HL-LHC Integration WP15

Crab cavities cryo-integration

M. Gonzalez de la Aleja, M. Sisti

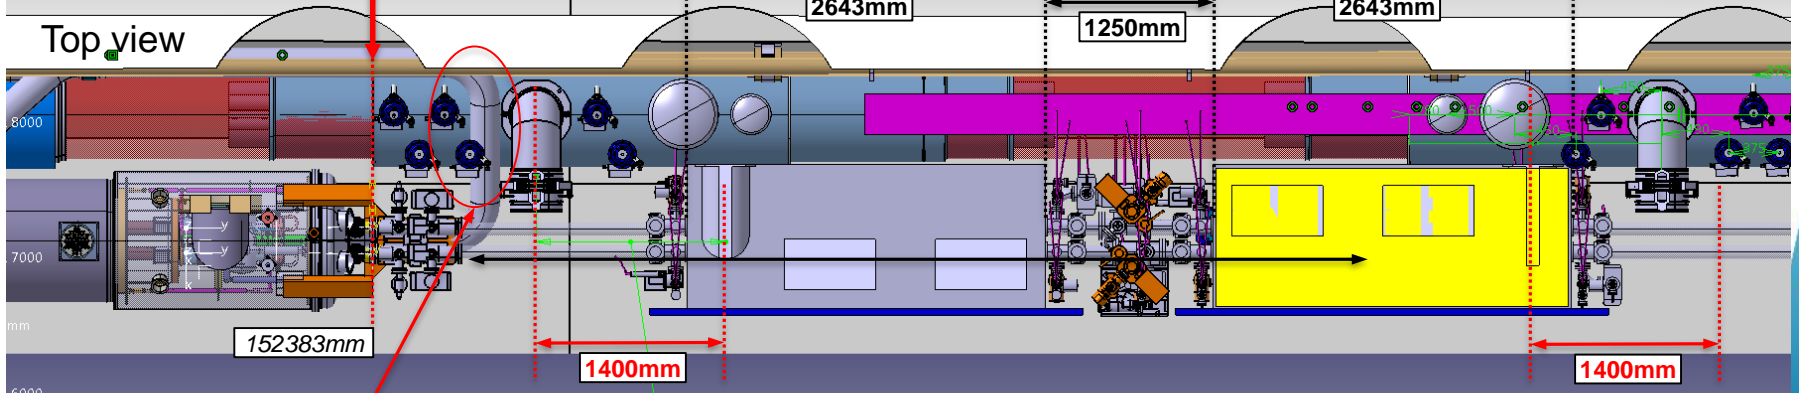
Faire passer le Sclink entre les vannes et le jumper (deplacer jumper +200mm vers l'arc)

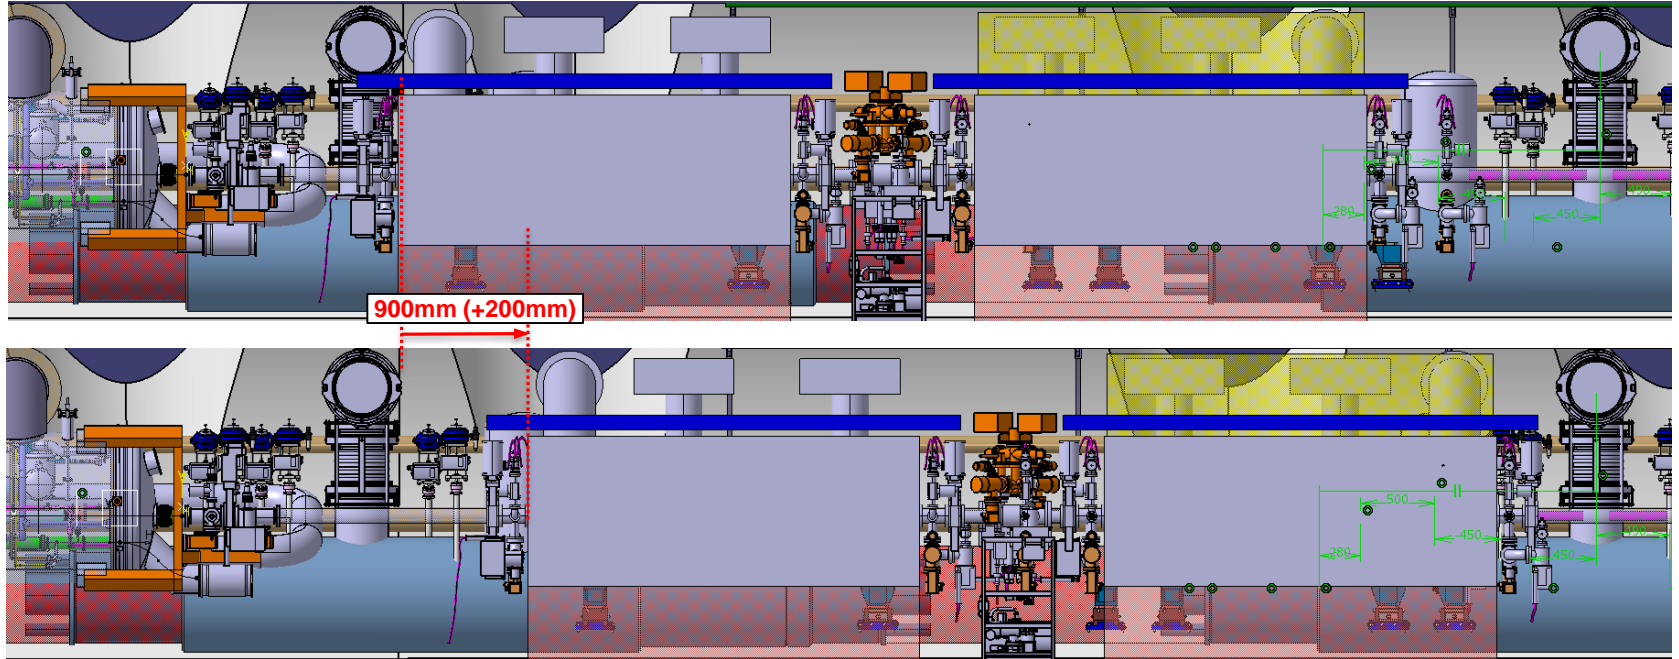
- Right flange of D2 is fixed (not modified): *152383mm from IP*
- Left flange of SM must be placed **aligned** with right flange of D2.
- Minimum distance between the jumper of the SM and the jumper of the CC: **1400mm**
- Not enough space for SCLink → **displace SM jumper +200mm** towards the arc

- TE-CGR will provide updated model of service model (jumper displaced 200mm towards the arc)
- Verify length between CC (vacuum). 1250mm
- Fix dimensions of Cryomodules: length and position of jumpers and wave guides. Provide 3D model
